EN L.P. Gas Water Heater
Product Change Notice

Effective immediately, L.P. Gas Water Heaters models WH-6GA, WH-6GEA, and WH-9GEA are undergoing a non-safety related change.

1 Current Door

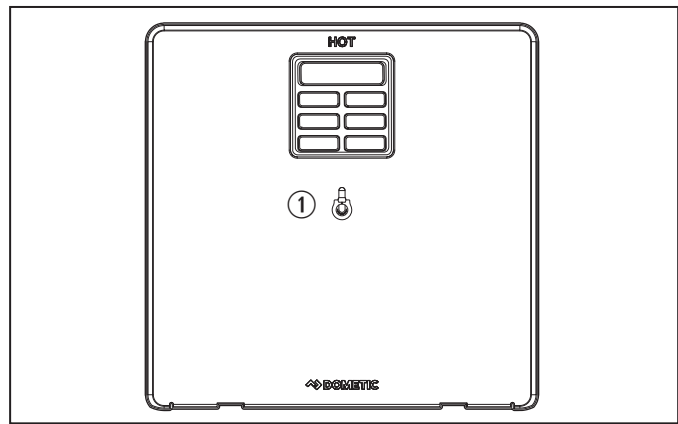
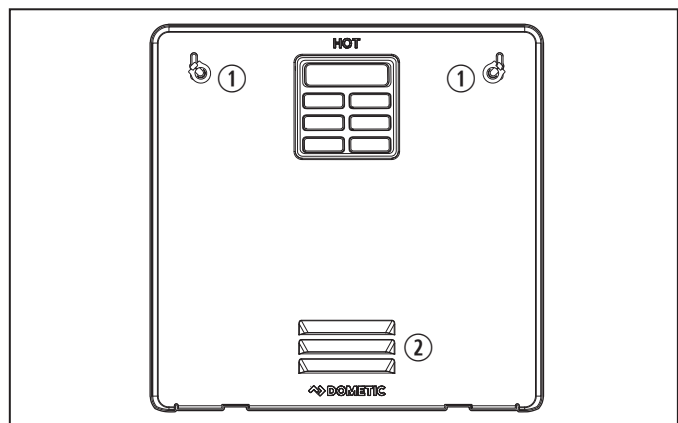
As part of an overall water heater redesign, latches have been added to the top corners to more securely hold the door and provide consistent spacing from the wall. The center latch has been removed.

Louvers have been added to improve air flow into the burner.

① Center Latch

① Top Latch

② Louvers

The current doors cannot be installed on the new water heater design.

As doors are ordered separately, care should be taken to avoid building up excess stock of the current doors.

A service kit will be available to retrofit water heaters of the old design with the hardware to install a new door.
